Part 2 Rebuttal Testimony of Dr. Clyde Thomas Williams

I. Clifton Court Forebay Not Being Expanded or Reconstructed

Cost Overrun vs. Scale of Investigation

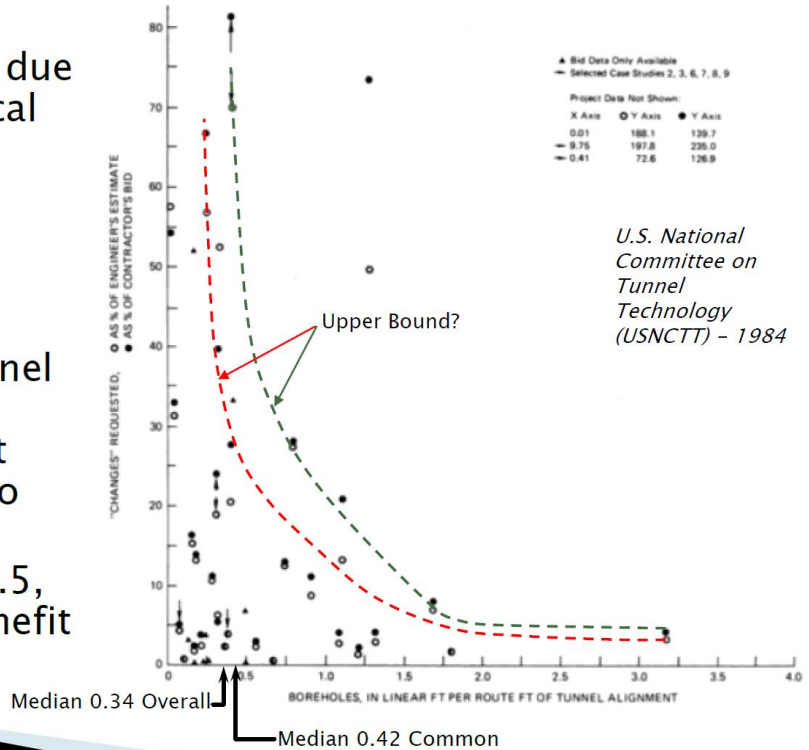
Investigation & Managing Geotechnical Risks In Tunnelling.⁶ The presentation includes the graph on the following page, showing the number of change orders to the projects he studied as a function of the number of boreholes per linear feet of tunnel route. The number of change orders goes up almost exponentially as the number of boreholes decreases. The boreholes for the WaterFix project are on the extreme lower end of the X axis on Masari's graph.

- ▶ Cost overrun due to geotechnical issues
- ▶ 84 projects, including 10 Canadian projects
- ▶ Borehole/tunnel ratio of 0.5: potential cost overrun, up to 60%
- ▶ B/T ratio > 1.5, not much benefit
